FINAL ENVIRONMENTAL IMPACT REPORT

EIR No. 96-0090-SUB(ZV)(CUB)(DA)
STATE CLEARINGHOUSE No. 96051050

Vesting Tentative Tract No. 52172

HARBOR GATEWAY CENTER

**Figure 7
Conceptual Area 1
Site Plan**

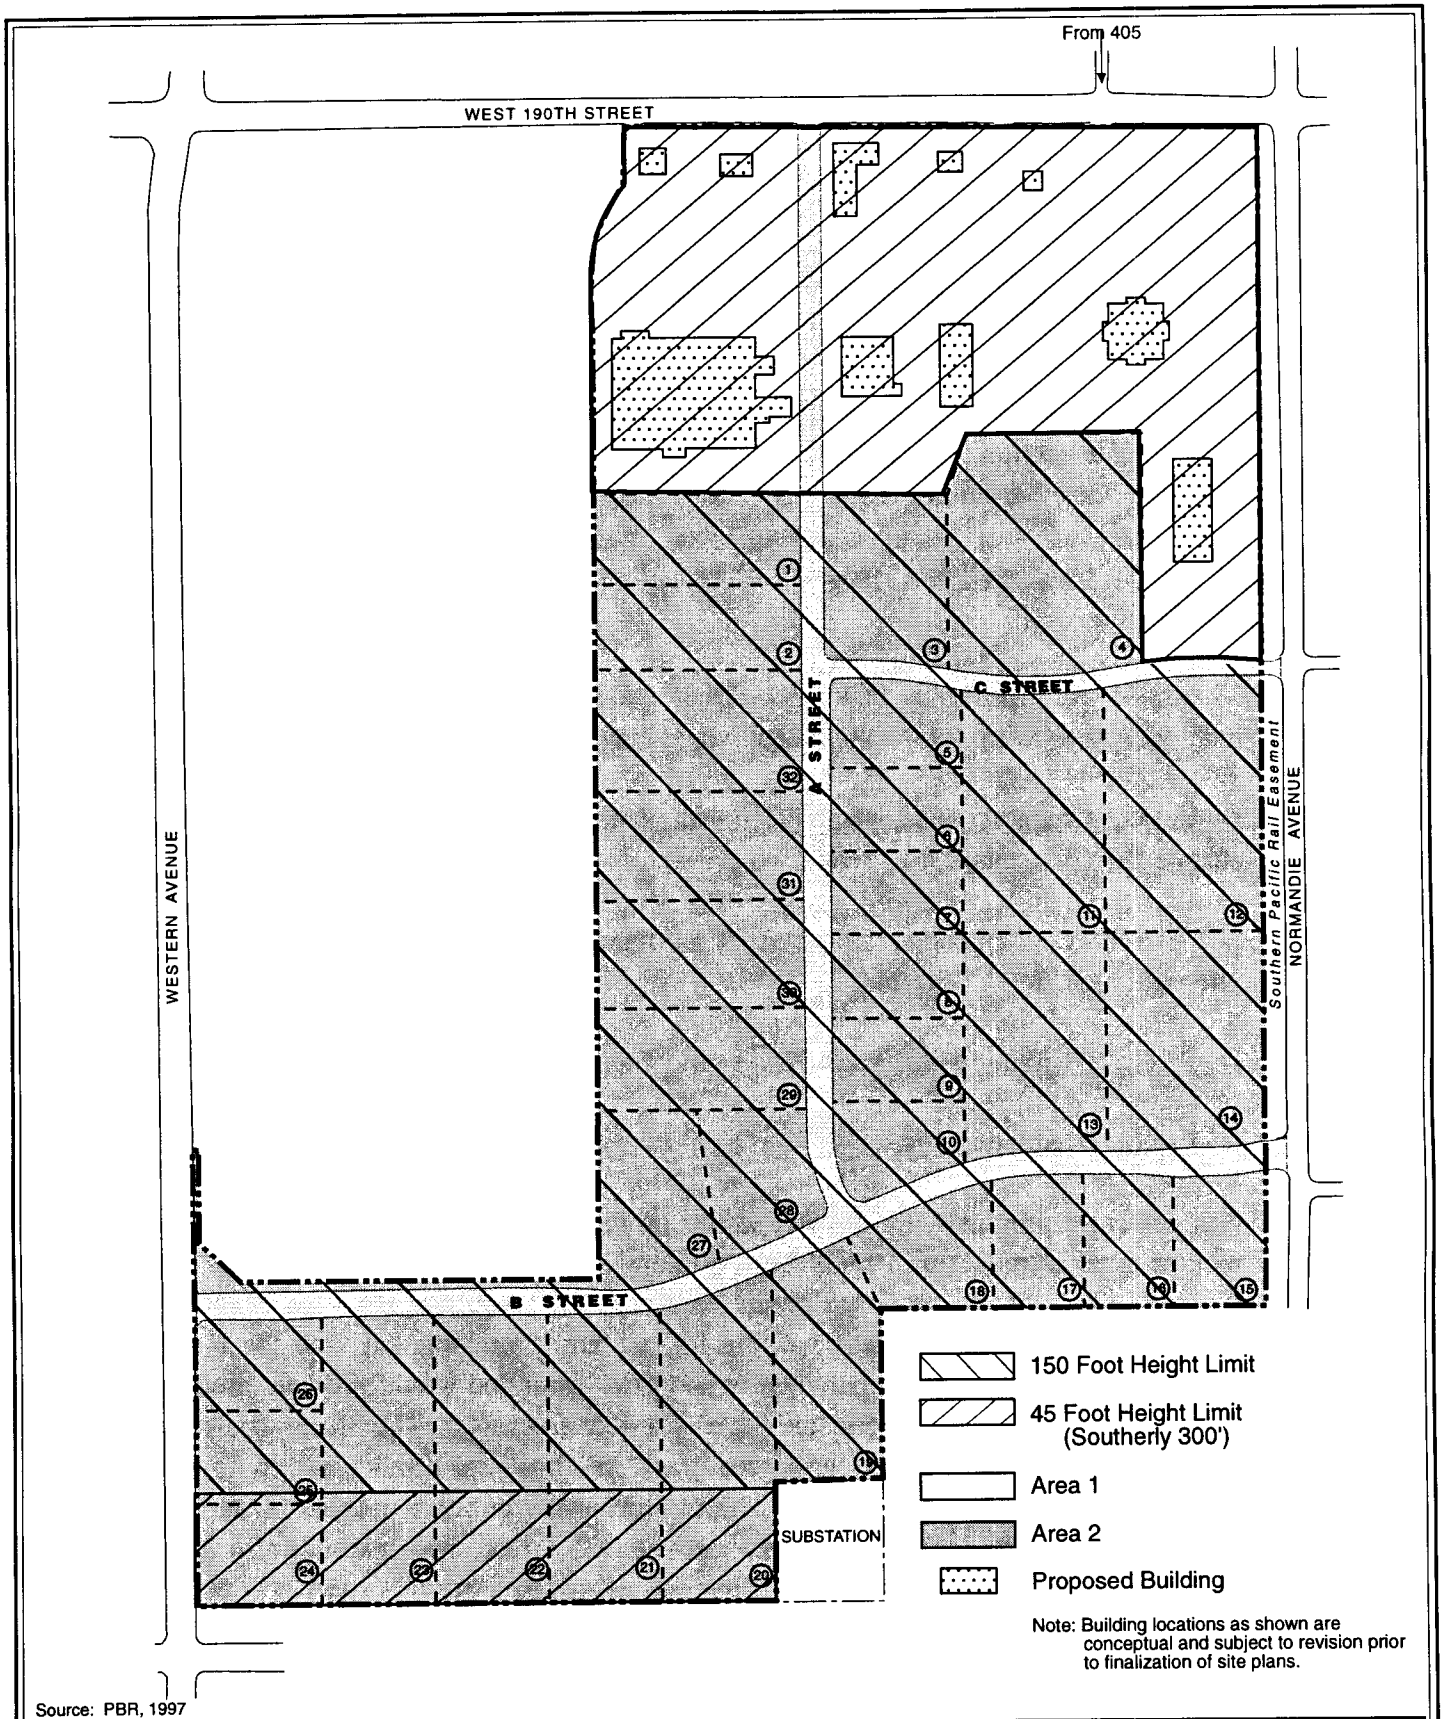
"Represents an approximately 0.25:1 FAR."
- l. D. Project Characteristics, page 66, first paragraph, fourth sentence, change "0.26:1" to "0.25:1".
- m. D. Project Characteristics, page 67, revise Figure 7 as shown on page 58.
- n. D. Project Characteristics, page 69, revise Figure 8 as shown on page 59.
- o. D. Project Characteristics, page 71, change the second paragraph under **a. Vehicular Circulation**, to read:

**Figure 10
Internal Circulation System**

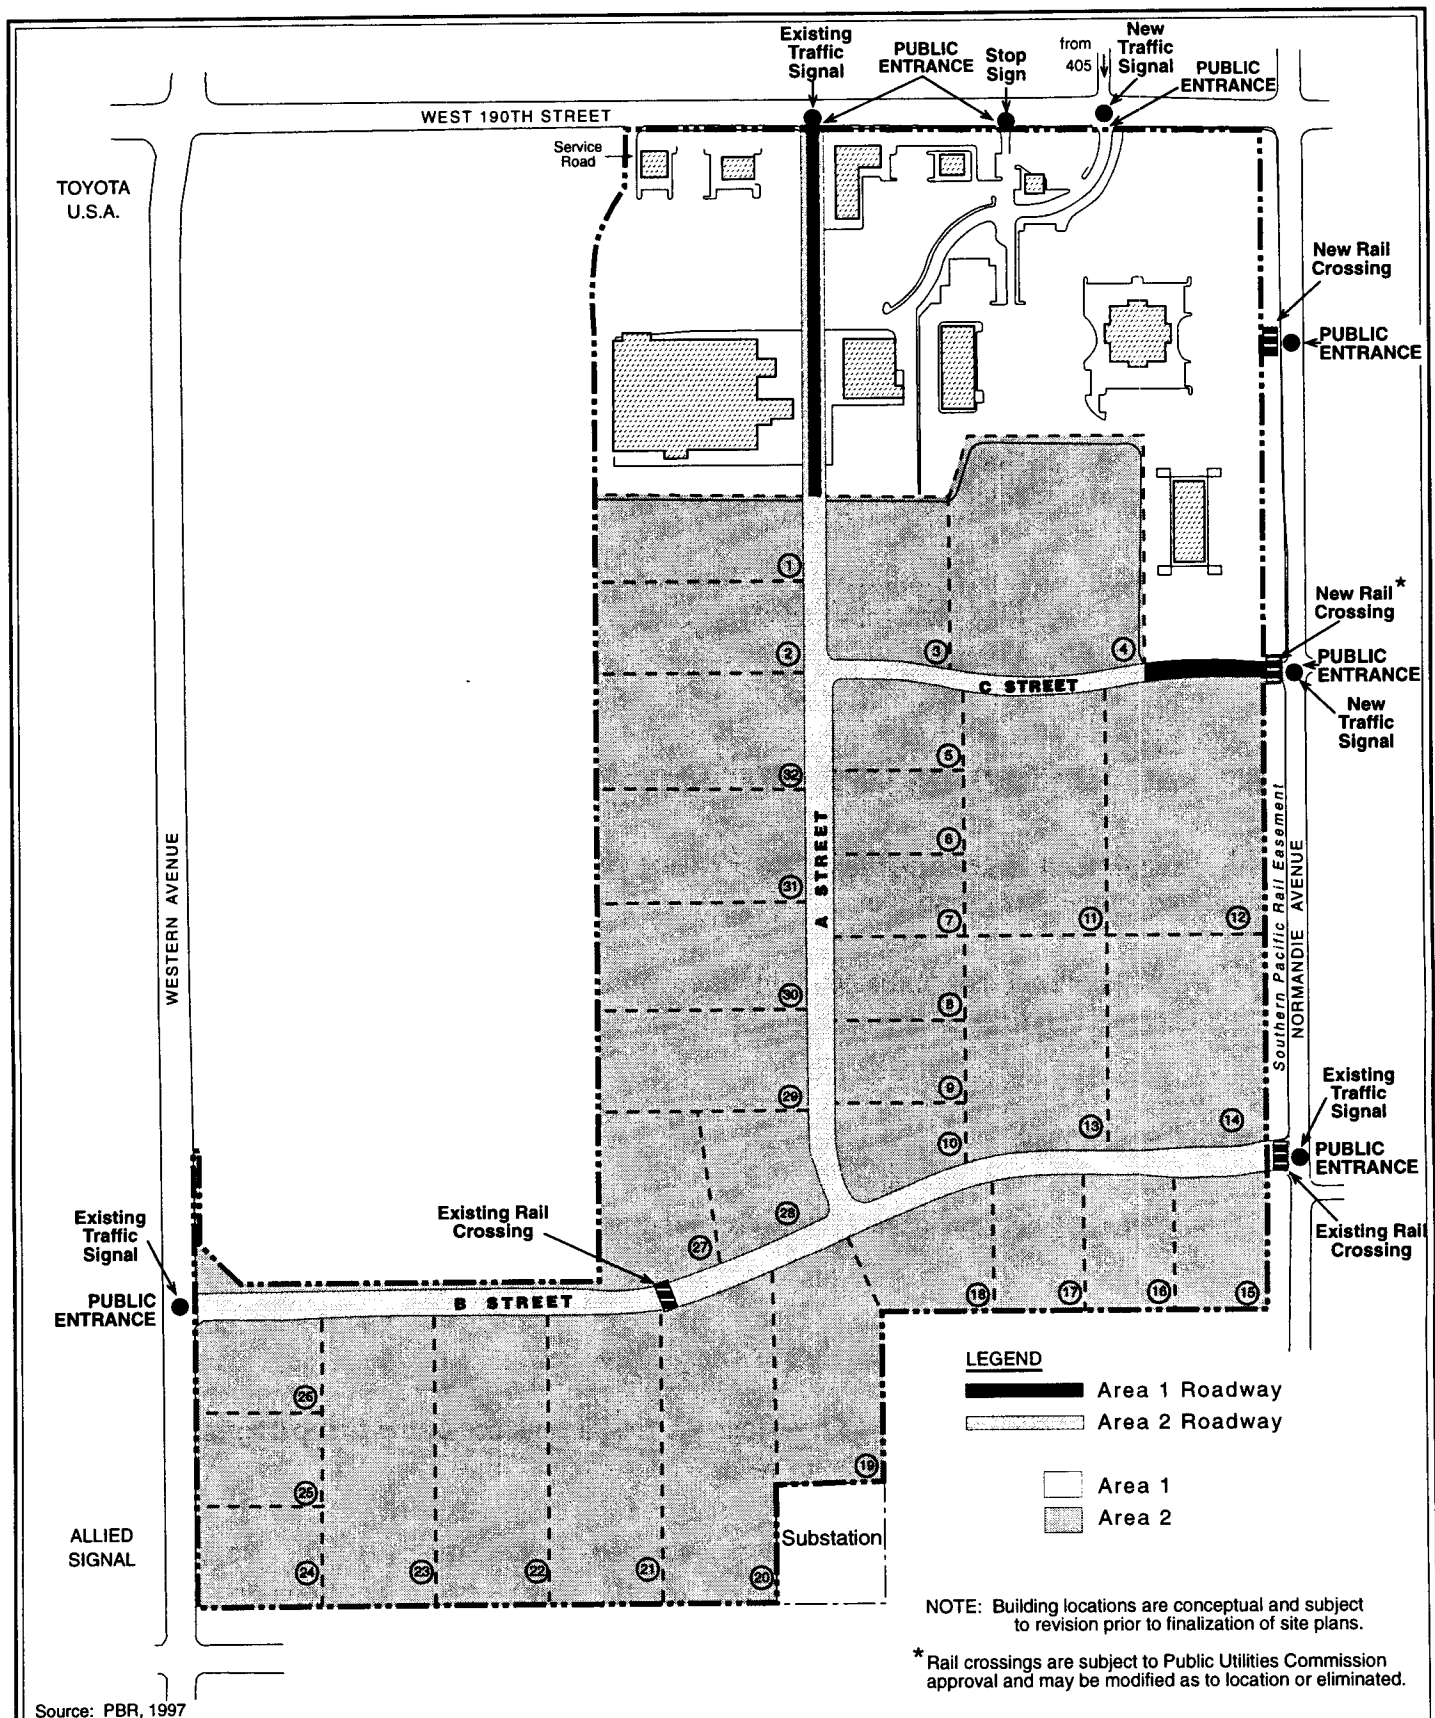
- s. D. Project Characteristics, page 72, revised Figure 10 as shown on page 61.

"As currently proposed, the project would provide six public entrances. These would include three entrances on 190th Street, two on Normandie Avenue, and one on Western Avenue. Two of the proposed public entrances on 190th Street would be driveways providing access to the Area 1 parking lot, including one aligned with the I-405 off-ramp, which is proposed to include a new traffic signal and would provide direct access to the retail center for traffic exiting the I-405 freeway. The third would be the proposed north-south ingress-egress roadway, which would provide access to Area 2, as well as serving the retail area. The two proposed public entrances on Normandie Avenue would include: (1) the proposed new "C" Street, which would also include a new rail crossing and would provide direct access to the eastern portion of Area 1 when the retail component of the project is built and would be extended to provide direct access to Area 2 when the industrial/office park component of the project is built; and

**Figure 14
Existing and Proposed
Storm Drains**

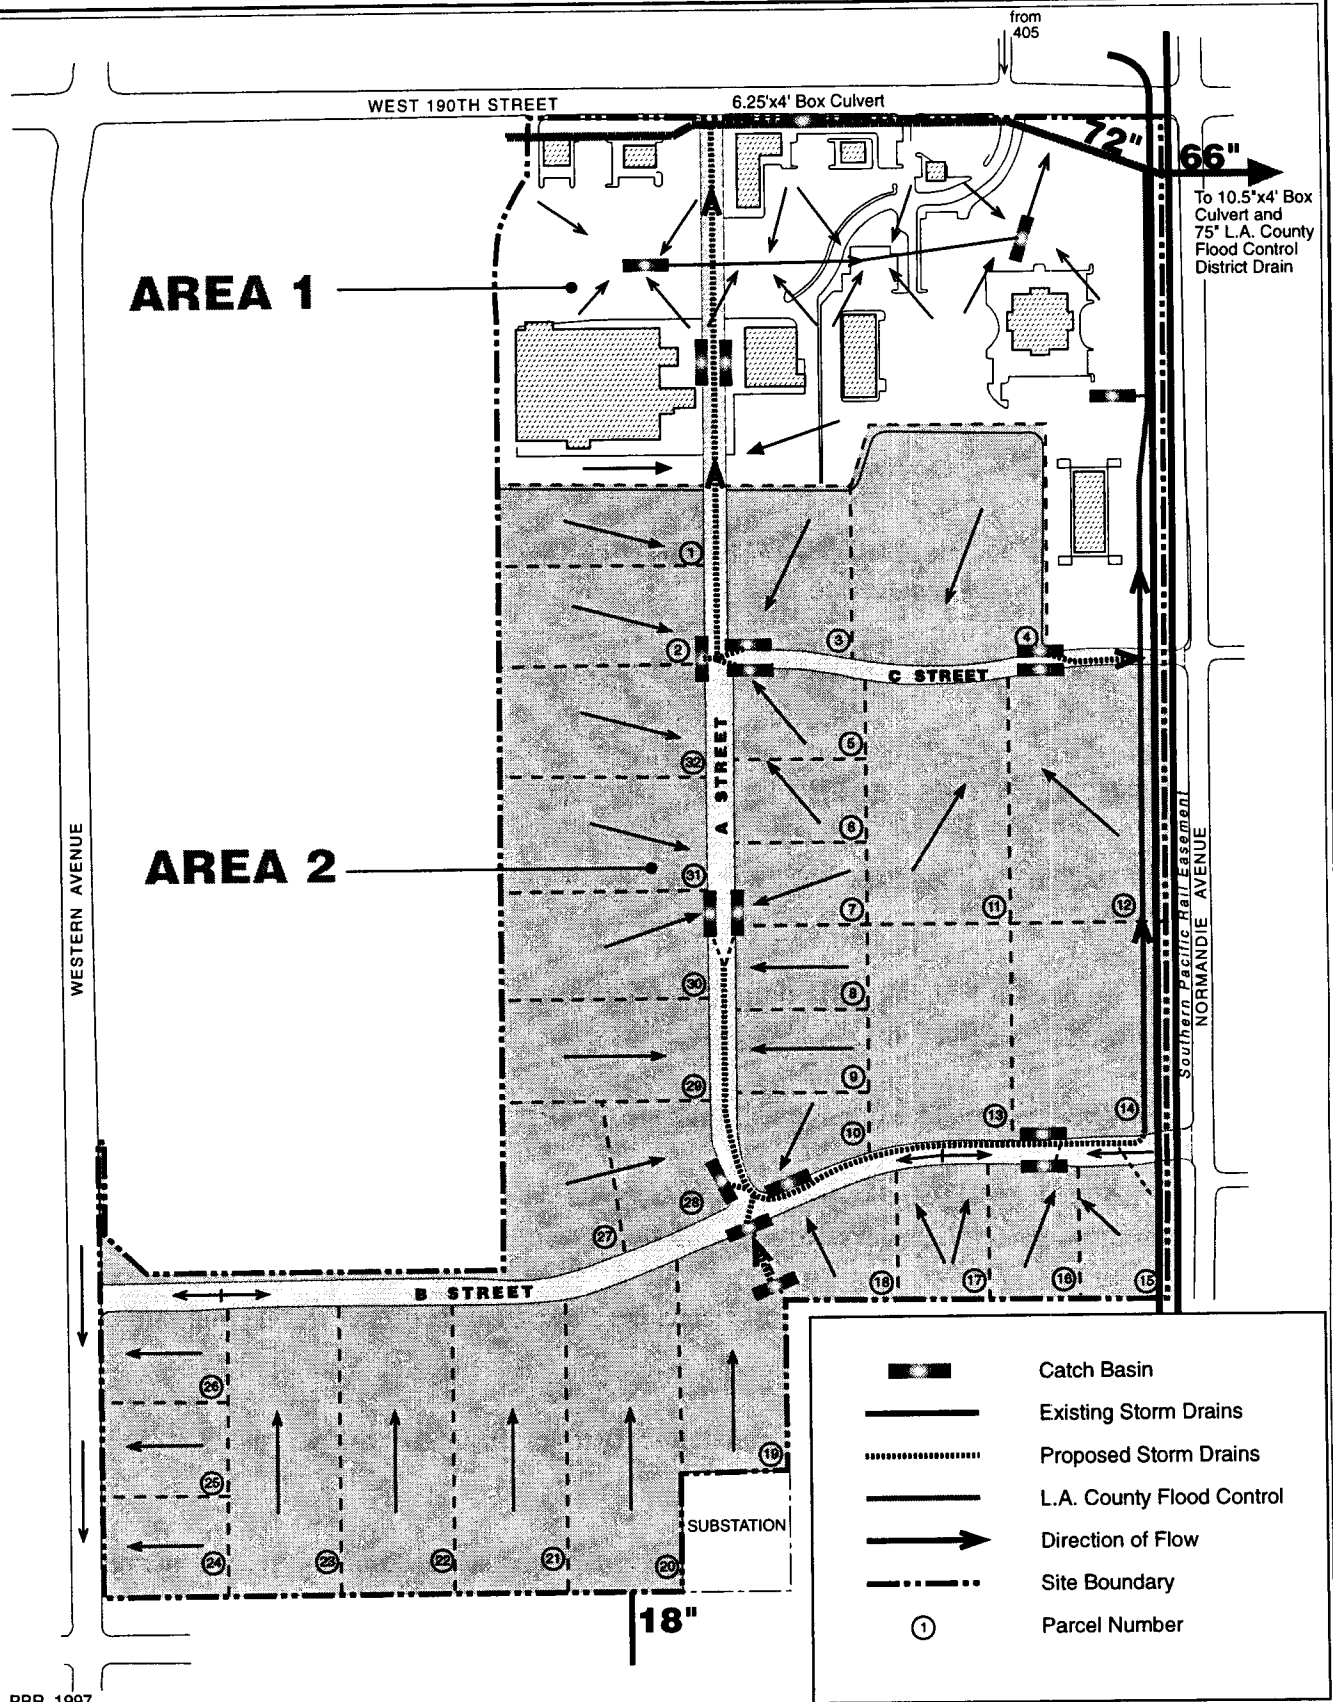
- a. Environmental Setting, page 126, revise Figure 14 as shown on page 63.

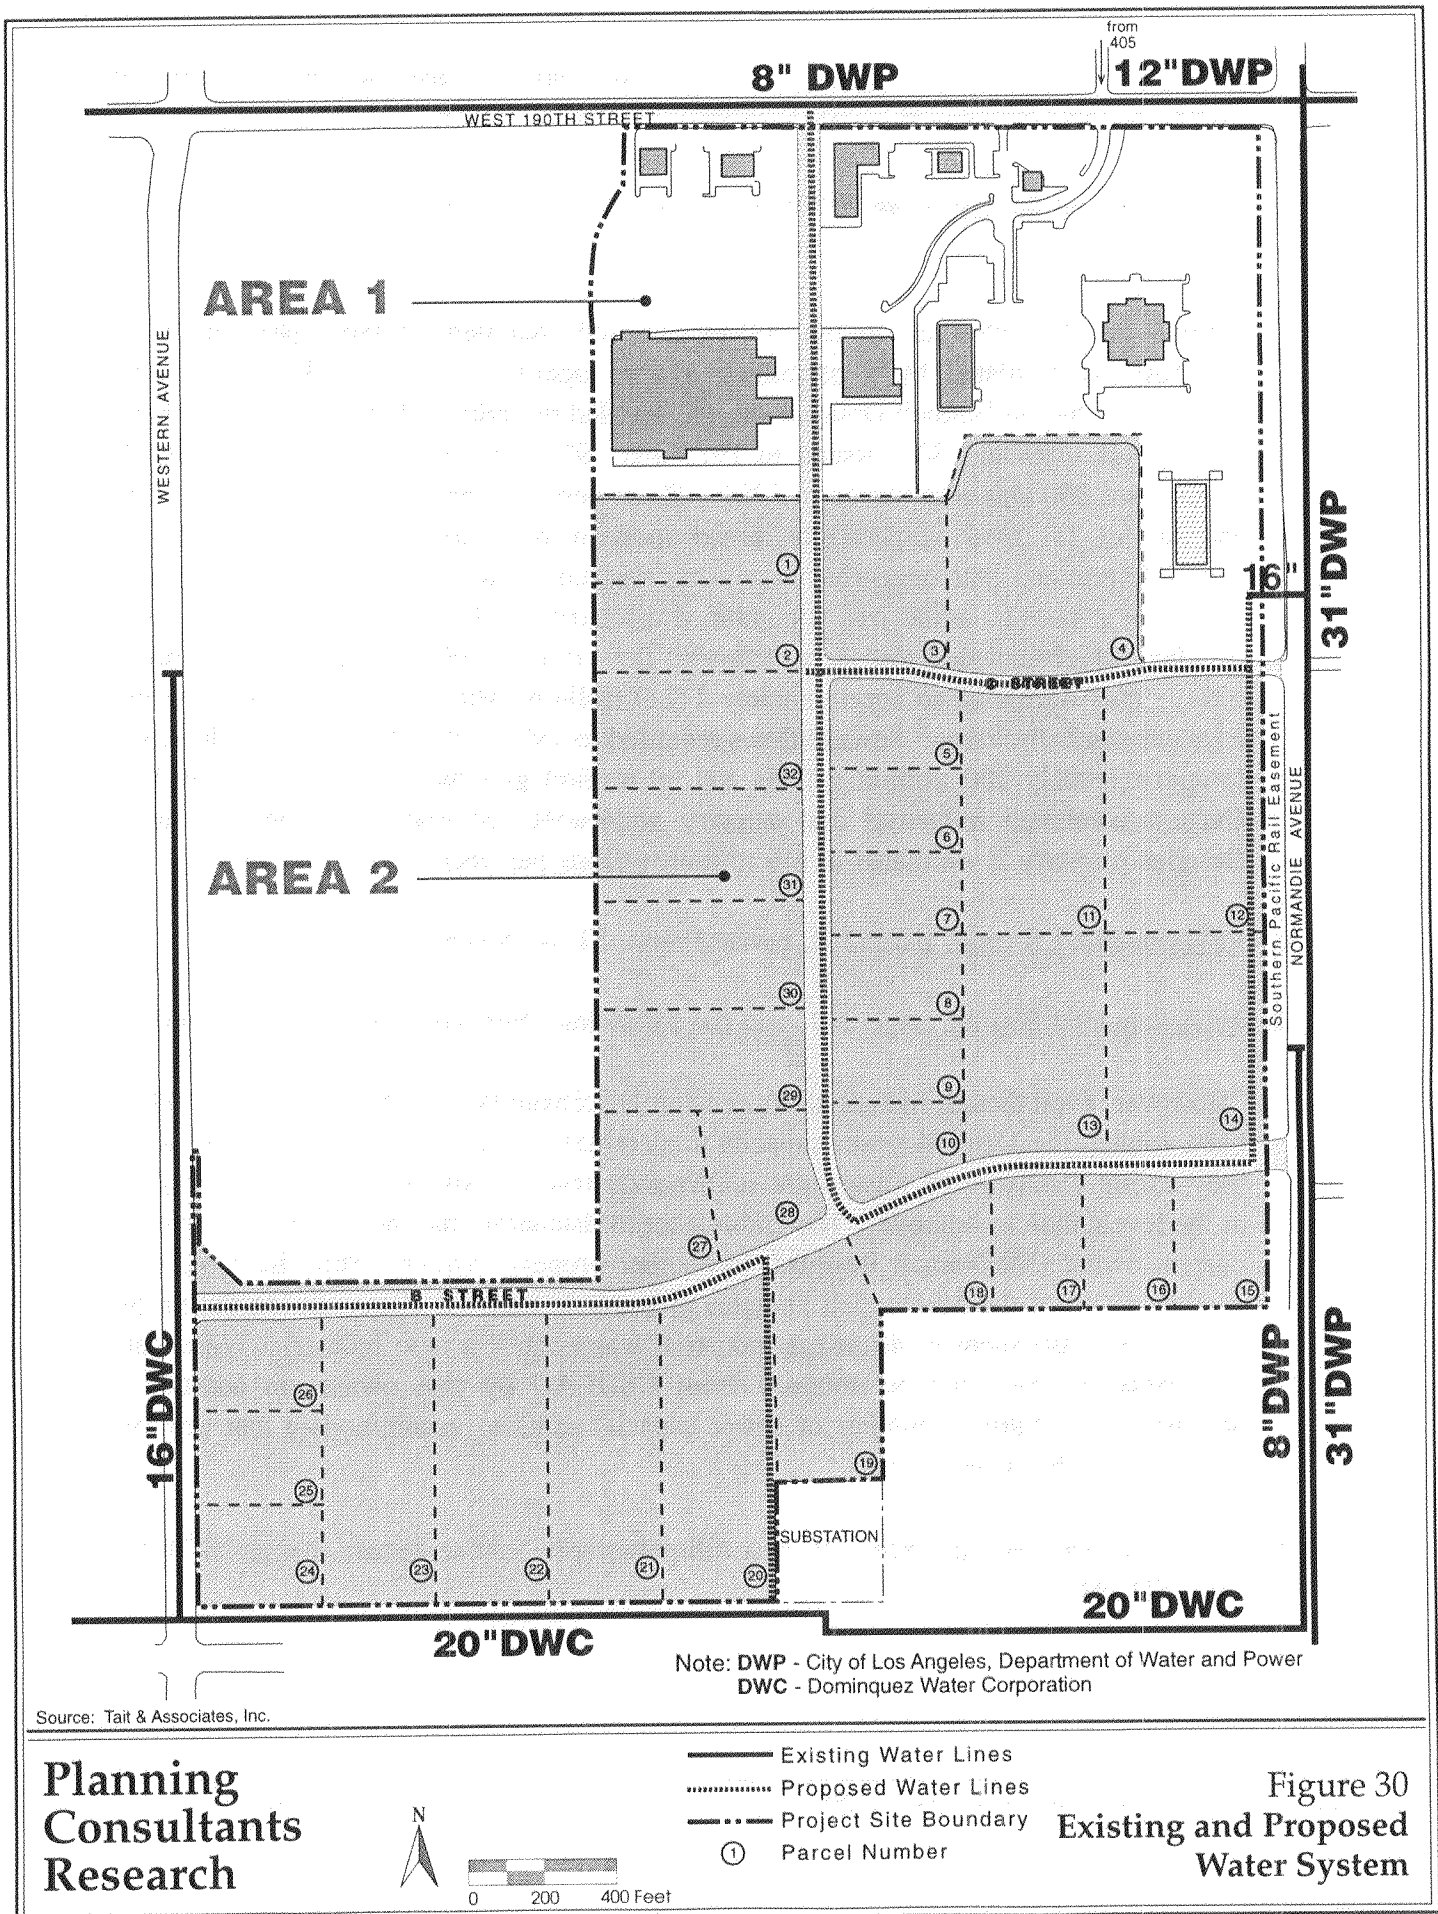
- a. Environmental Setting, page 271, revise Figure 30 as shown on page 69.
- b. Project Impacts, page 272, change the fourth sentence of the second full paragraph to read:

New water lines would connect to both the 8 to 12-inch DWP line in 190th Street and the existing 16-inch line located on-site which ties to the 31-inch DWP line in Normandie Avenue.
